Project	<b>IEEE 802.16 Broadband Wireless Access Working Group</b> < <a href="http://ieee802.org/16">http://ieee802.org/16</a> >
Title	<b>Quasi-Random Ranging Code and Ranging Sub-channel Selection in OFDMA System.</b>
Date Submitted	<b>2002-03-05</b>
Source(s)	KiHo Chung, DaeEop Kang, JungMin Ro Samsung Electronics 416, Maetan-3dong, Paldal-gu Suwon-si, Gyeonggi-do, Korea Voice: +82-31-279-5097 Fax: +82-31-279-5130 <a href="mailto:khchung@samsung.com">mailto: khchung@samsung.com</a> , <a href="mailto:dave@samsung.com">dave@samsung.com</a> , <a href="mailto:clairero@samsung.com">clairero@samsung.com</a>
Re:	[If this is a proposed revision, cite the original document.]
Abstract	This document contains the concept of Quasi-Random Selection of Ranging Code and Ranging Sub-channel for the 802.16a system
Purpose	This proposal should be used for the Ranging design.
Notice	This document has been prepared to assist IEEE 802.16. It is offered as a basis for discussion and is not binding on the contributing individual(s) or organization(s). The material in this document is subject to change in form and content after further study. The contributor(s) reserve(s) the right to add, amend or withd

**Figure 14 1 - Bandwidth Request in OFDMA**

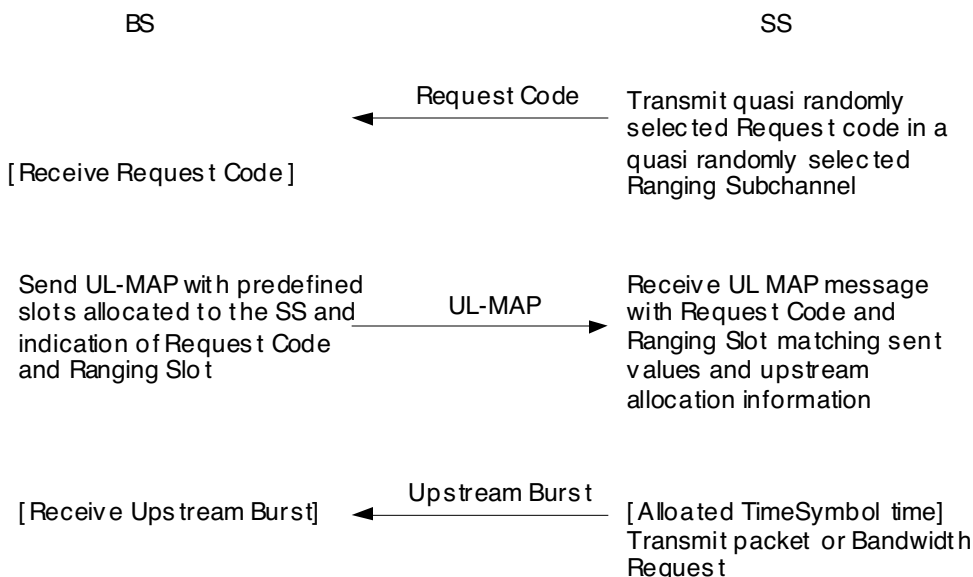
Because Connection ID is unique, SS can choose the Ranging Code and Ranging Sub-channel using the following equation like a random selection quasi-randomly.

Ranging Code Index = Connection ID mod The number of Ranging Codes on AP

Ranging Sub-channel Index = Connection ID mod The number of Ranging Sub-channel on AP

Replace the figure 141 of subsection 6.2.6.5 with the following
